CONVAIR

COMMERCIAL CHANGE PROPOSAL

SPEC NO.: ZD-22-327 DATE: _____

TITLE: Specification Administrative Change (Revision to Portable Oxygen Bottle Part Number - Group C Airplanes)

FLIGHT INSTRUMENTATION DIAGRAM

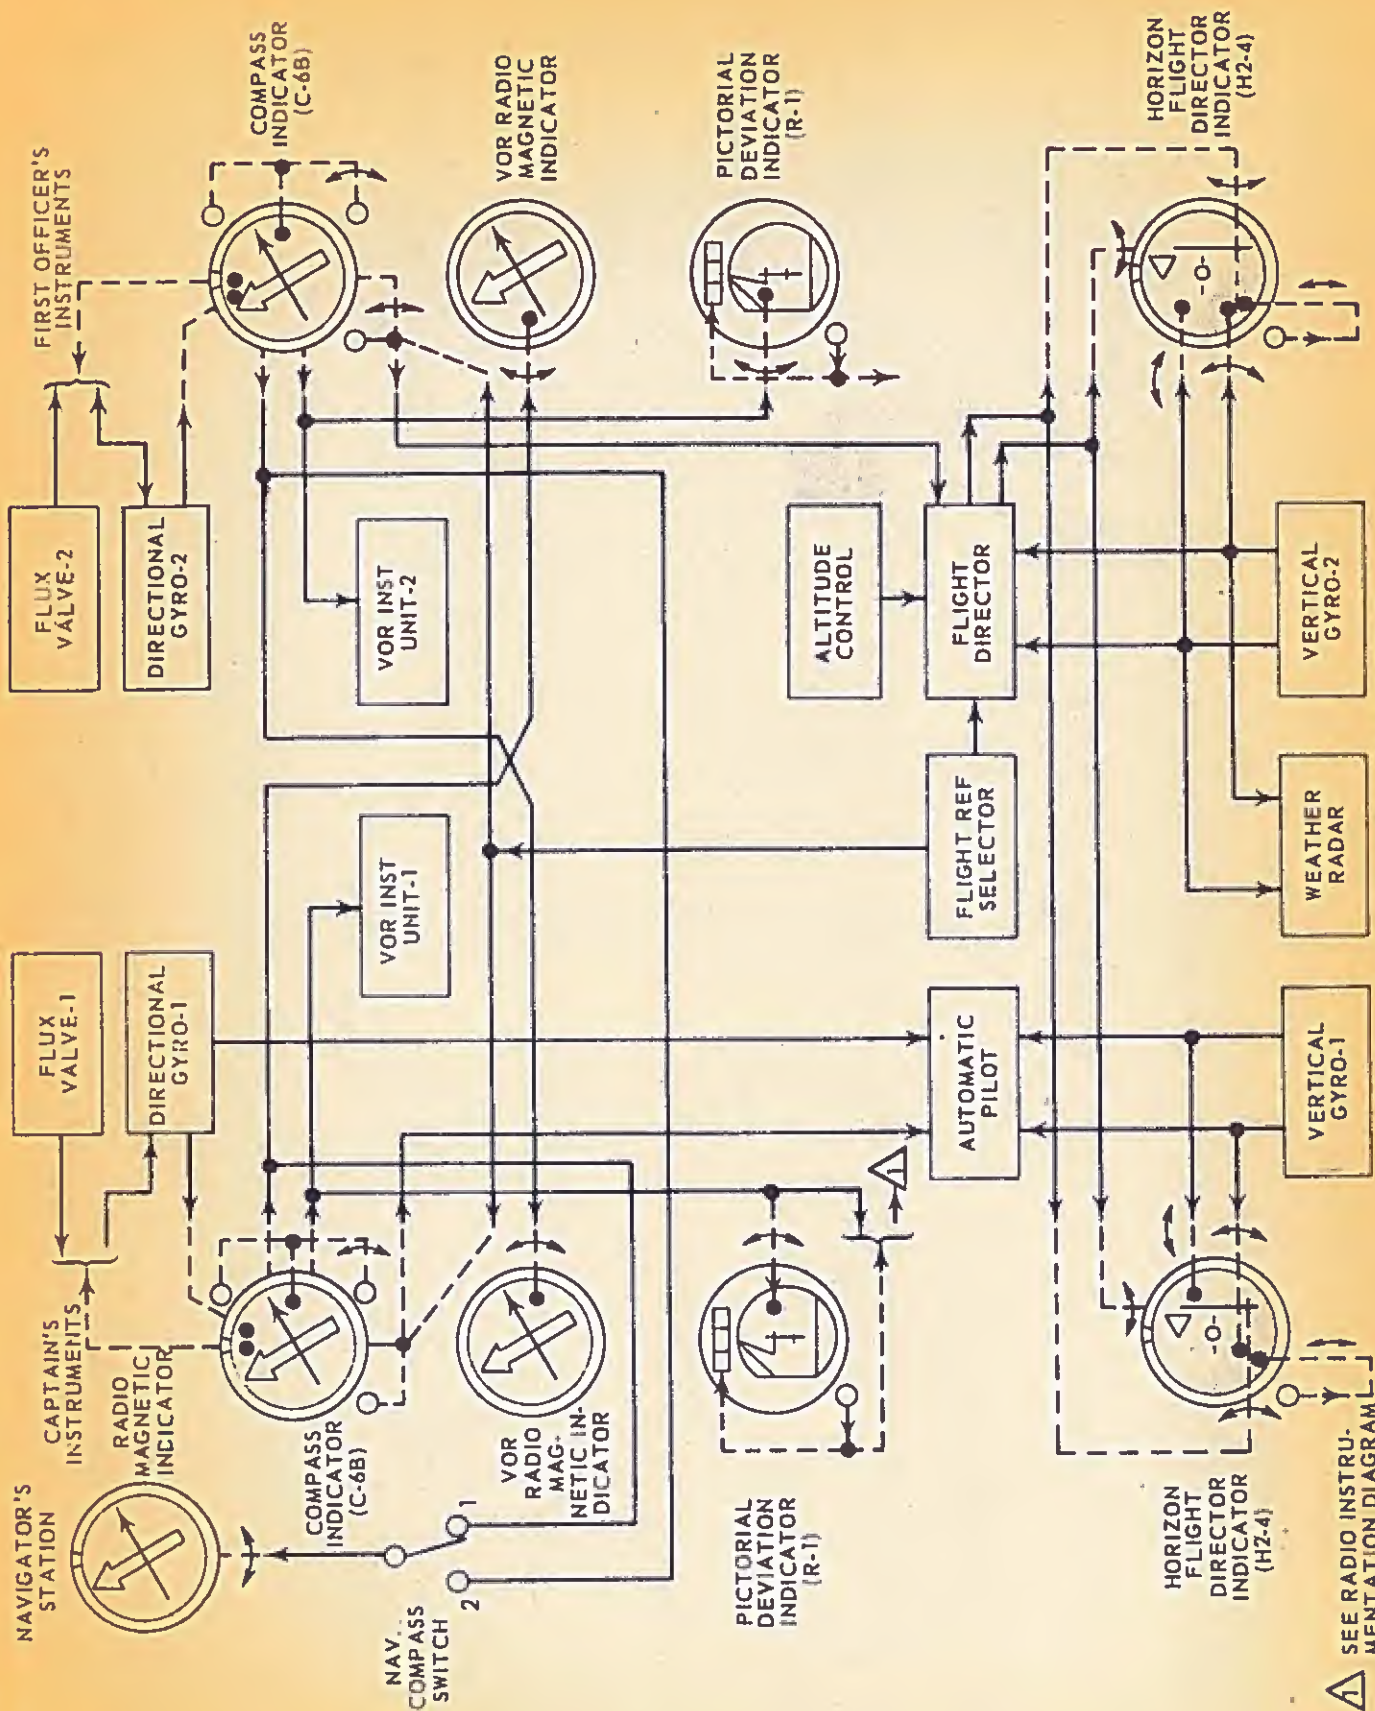
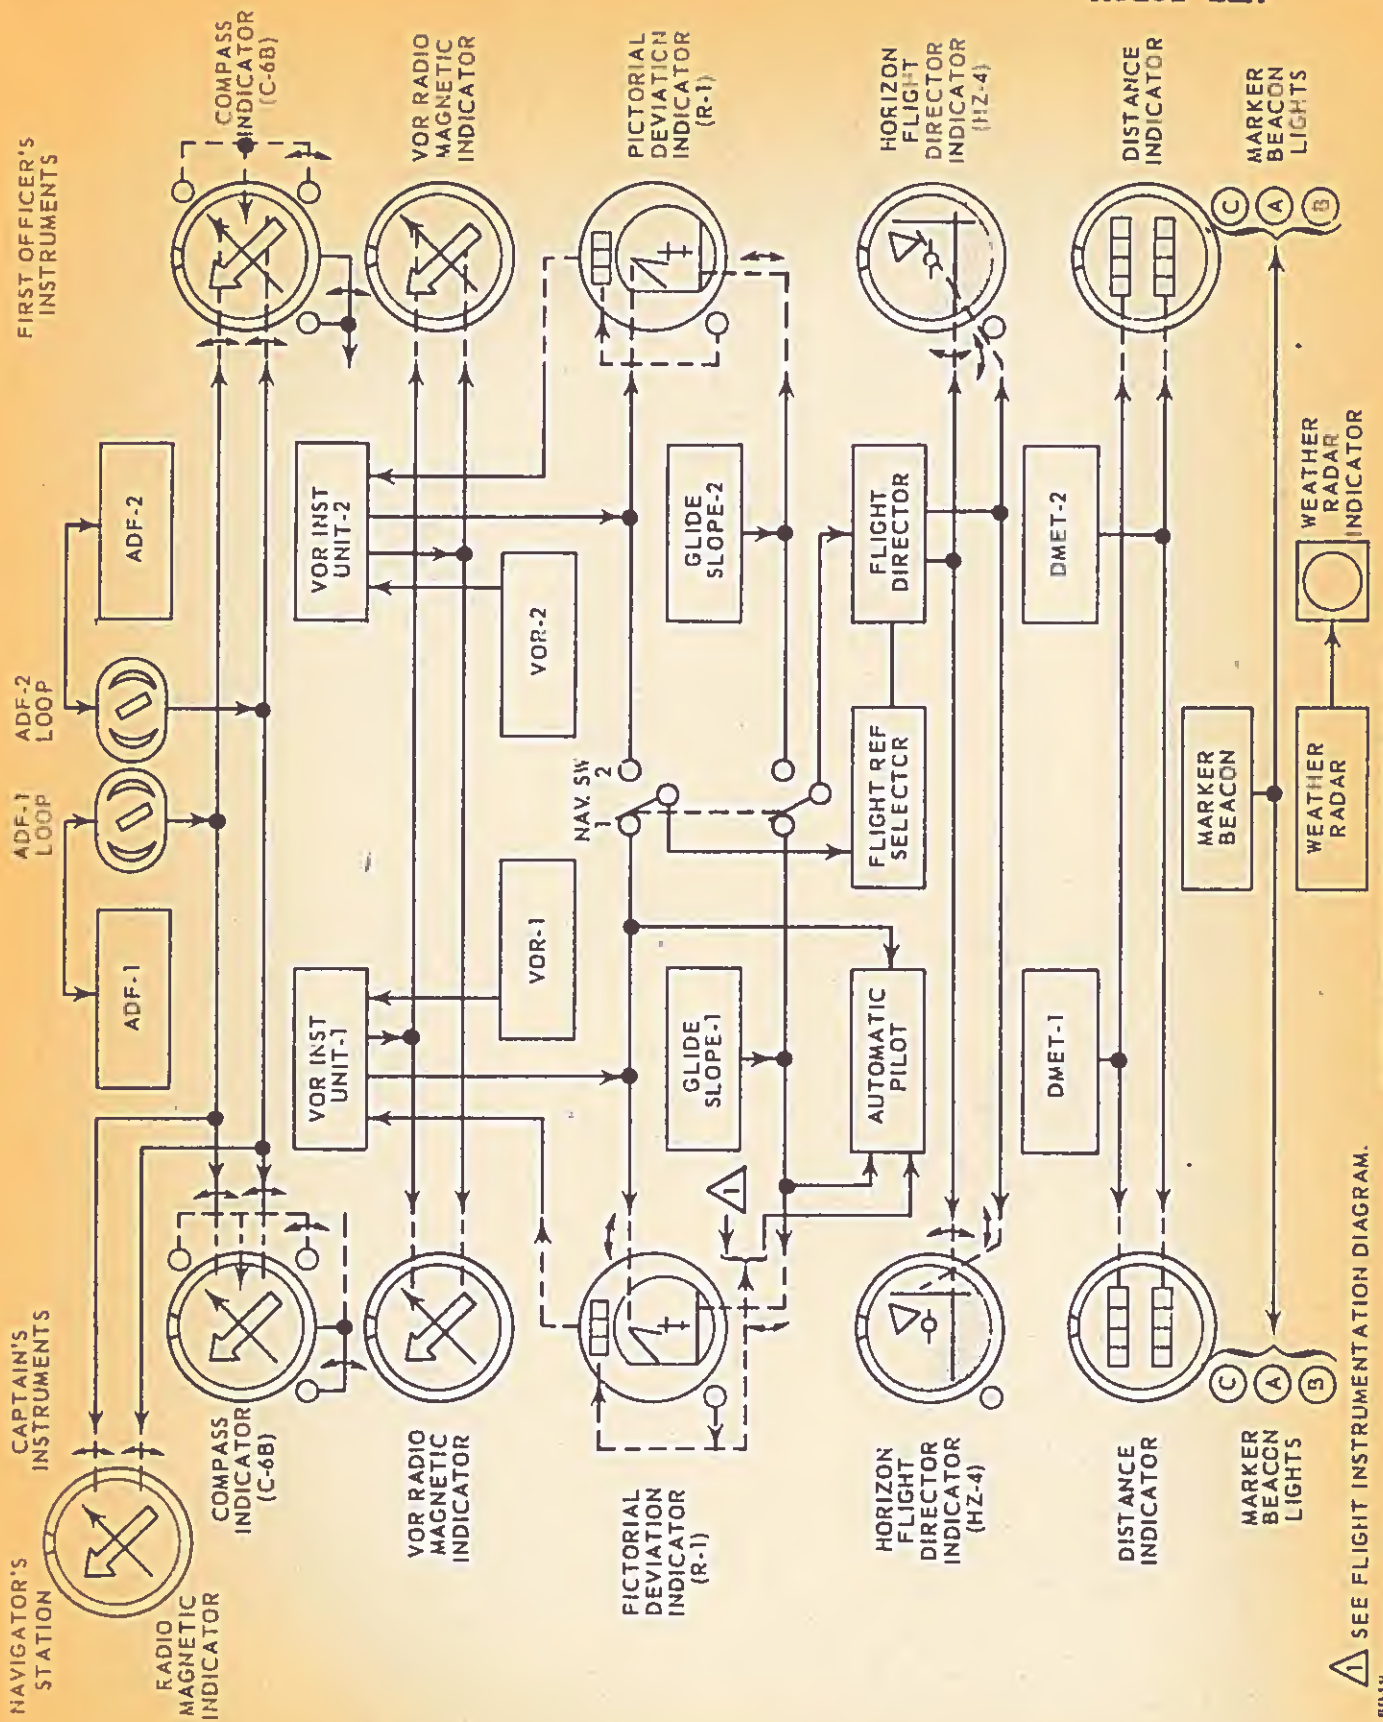
Delete all description after the second sentence, and add the following new paragraphs, after Paragraph 3.17.3.4.2:

"3.17.3.4.3 INSTRUMENTATION: Pilot's PDI (R-1) shall display information from No. 1 VHF navigation system and No. 1 glide slope, whereas copilot's PDI shall display information from the No. 2 VHF navigation system and No. 2 glide slope. The course selector of pilot's PDI shall supply signal to the No. 1 VHF navigation system, whereas the course selector of copilot's PDI shall supply signal to the No. 2 VHF navigation system. The single and double pointers on pilot's and copilot's RMI shall display information from the No. 1 and No. 2 VHF navigation systems respective. The automatic pilot shall receive deviation and mode control signals from the No. 1 VHF navigation system and No. 1 glide slope, and shall receive VOR selected course signals from pilot's PDI.

3.17.3.4.4 VHF NAVIGATION SIGNAL FOR FLIGHT DIRECTOR: A flight director transfer switch with "VOR/ILS-1" and "VOR/ILS-2" positions shall be installed. Two flags, each with "VOR/ILS-1" and "VOR/ILS-2" positions shall be installed. (See Page 44a.) When the transfer switch

PILOT'S AND COPILOT'S INSTRUMENT PANELS

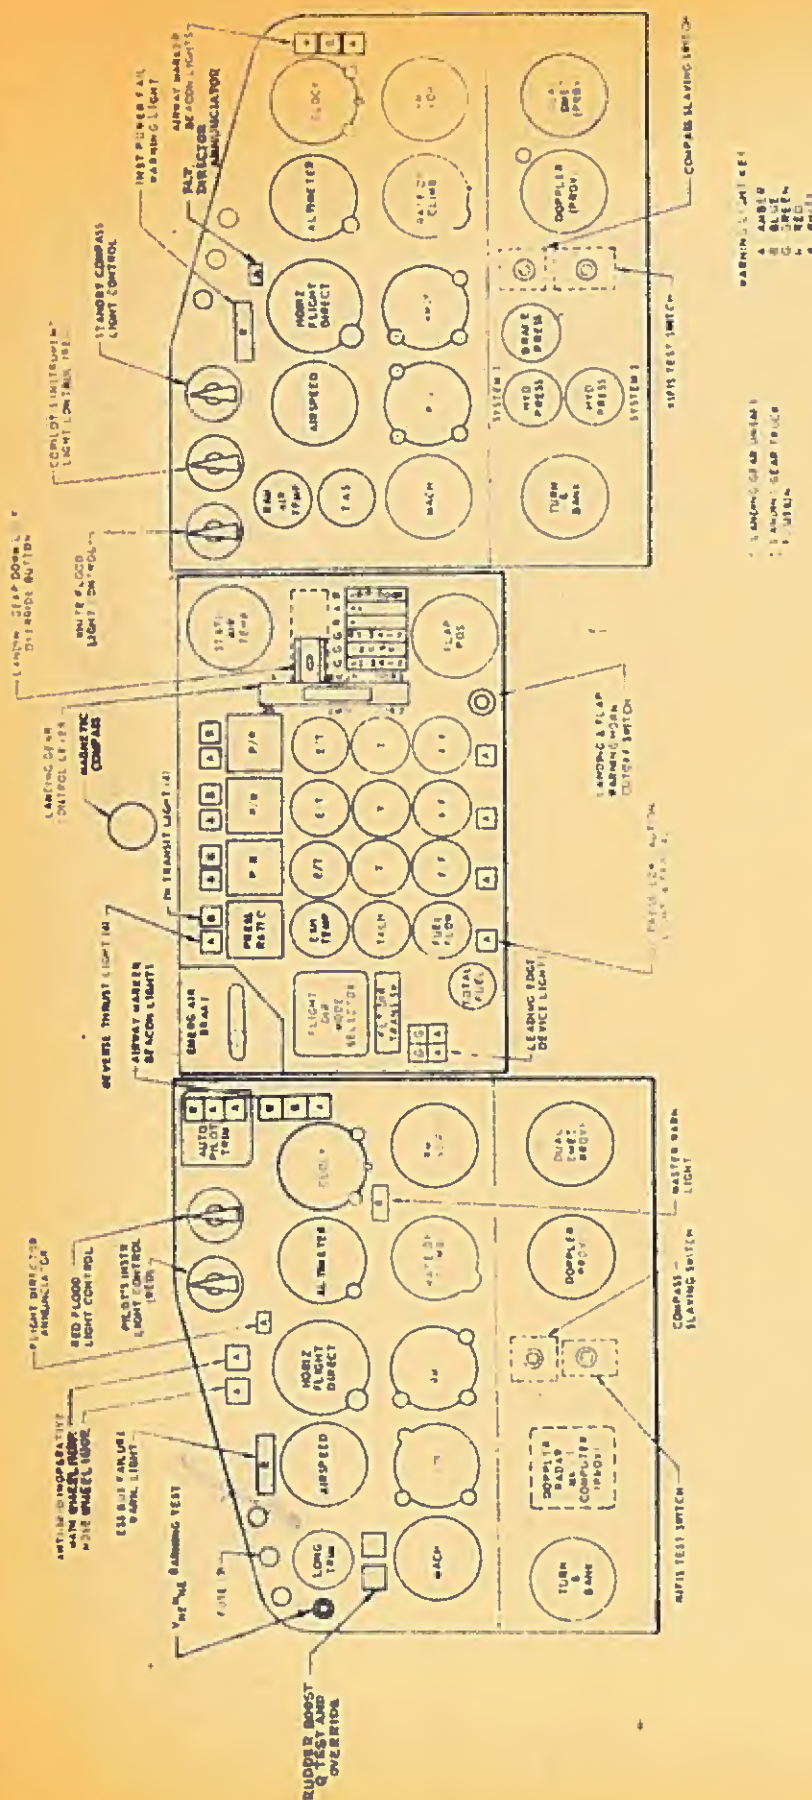
Replace above illustration in the specification with Enclosure (A) which deletes "MAIN LANDING GEAR" and "NOSE LANDING GEAR" on pilot's panel and adds "MAIN WHEEL INOP." and "NOSE WHEEL INOP."

Page 7a, C. G. DESIGN LIMITS:

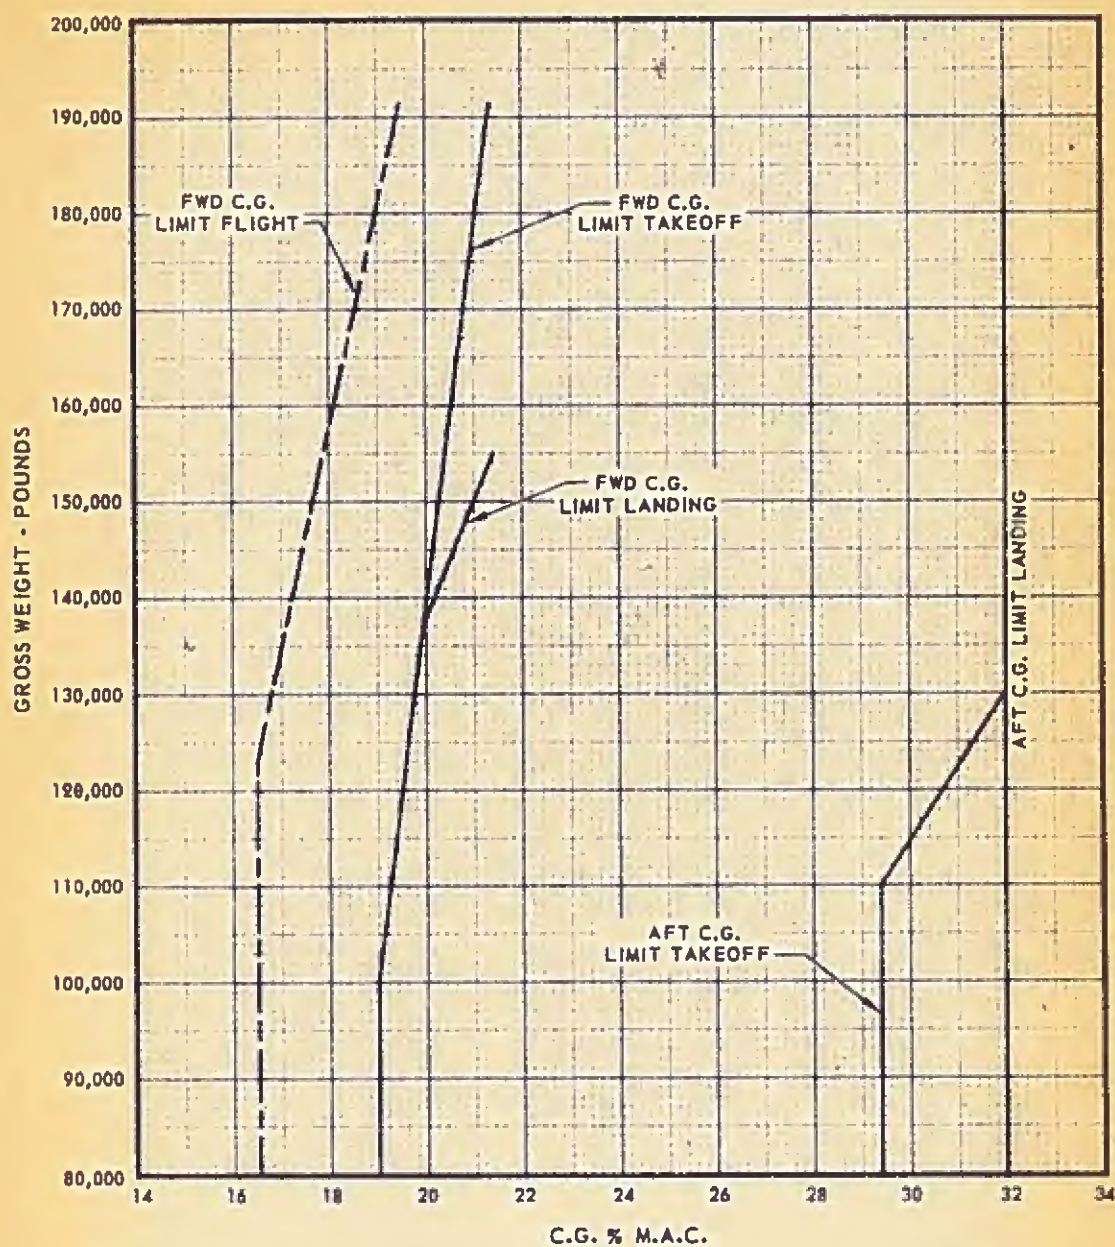
Reason for Change: To furnish an up to date C. G. Limits Graph.

Page 44b, PILOT'S AND COPILOT'S PEDESTAL:

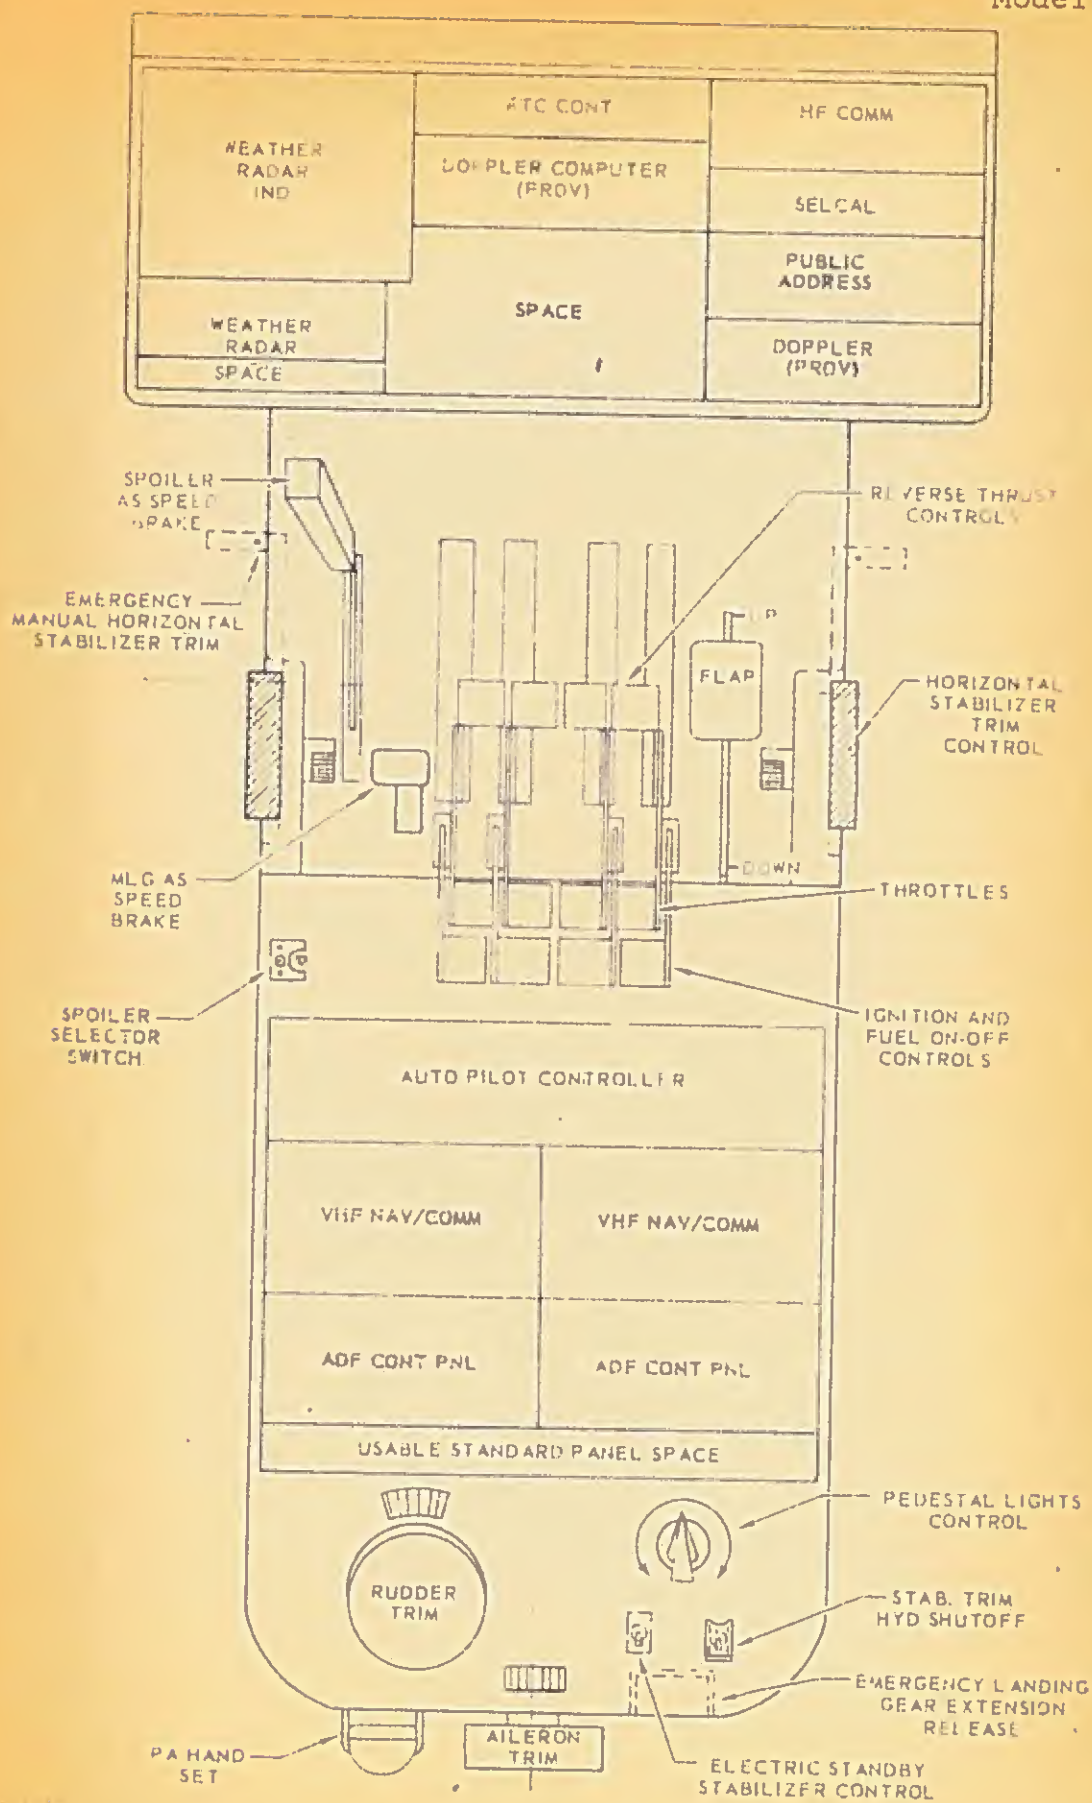
Replace above illustration in the specification with Enclosure (B), which deletes "MALFUNCTION LIGHTS".
